Our Ref: R/2025/21  
File No: 2025/703352

**Request for Advice - Exhibition of [SSD-80441462 Waterloo Mixed Use Development 881-885 Bourke Street](#)**

Thank you for your correspondence dated 12 November 2025 inviting the City of Sydney (the City) to comment on the exhibition of the main works application for the mixed-use development at 881-885 Bourke Street Waterloo.

Figure 2 - extract from Page 6 of Appendix “E3 Architectural Design Report A2 Solar Access”

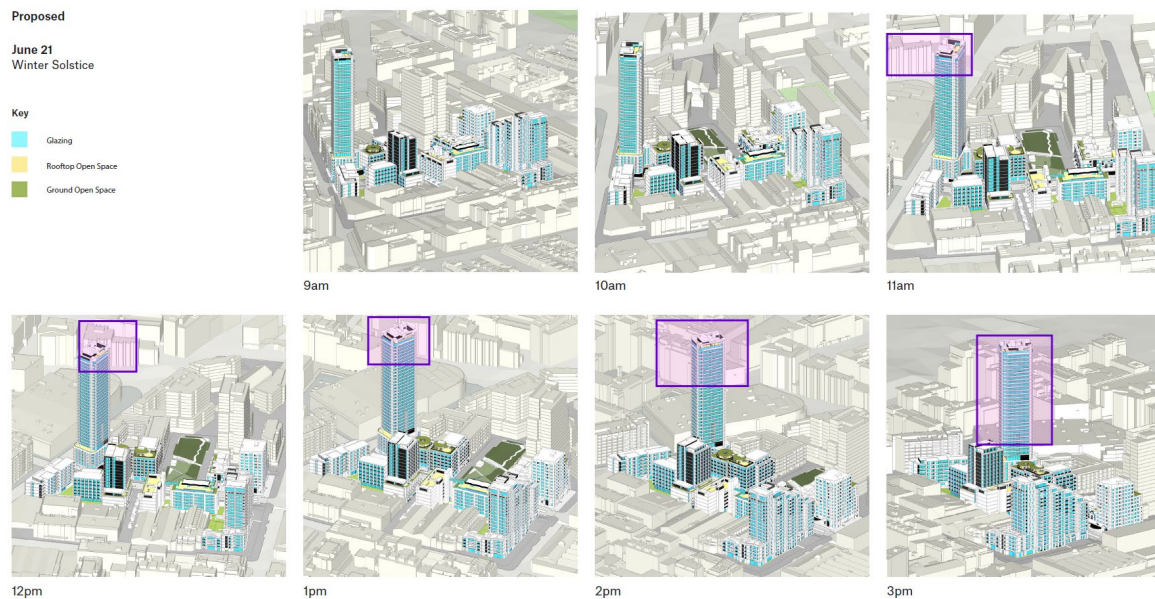
- b. The proposal clusters building mass (11 to 19 storeys) at the north-west of the site (Parcel 1), fronting Young Street and the tallest 36 storey tower at the south-eastern corner of the site fronting Bourke Street (Parcel 3). The massing along Young Street has the potential to significantly adversely impact on future development solar access compliance to a building’s eastern and northern façade, to the extent where a building cannot achieve consistency with the ADG 70% design criteria.
- c. The 36-storey tower at Parcel 3 impacts a number of buildings on the south side of Lachlan Street. No information or adequate assessment has been provided on the extent of impact to these properties, other than hourly sun’s eye diagrams with no quantified assessment. Extract of these locations of no quantified assessment at indicated at **Figure 2** with purple shading.

- i. Fully document all affected developments that are subject to overshadowing impacts by the tower in the south-eastern Parcel 3, in line with the City of Sydney's "[Minimising Overshadowing of Neighbouring Apartments Documentation Guide](#)" and demonstrate how overshadowing has been minimised per the requirement of the ADG (Objective 3B-2 Overshadowing of neighbouring properties).

- ii. If this cannot be documented, the south-eastern tower at Parcel 3 should be reduced from 36 to a maximum 25-storeys in height.
- iii. The Parcel 1 and Parcel 4 massing should be reduced in height and storeys, and analysis provided to demonstrate that the upper 50% of the façade for a 6-storey building mass (as permitted by the Sydney Development Control Plan 2012), will receive 2 hours solar access. This provide opportunity for future development off the western side of Young Street to achieve adequate solar access.
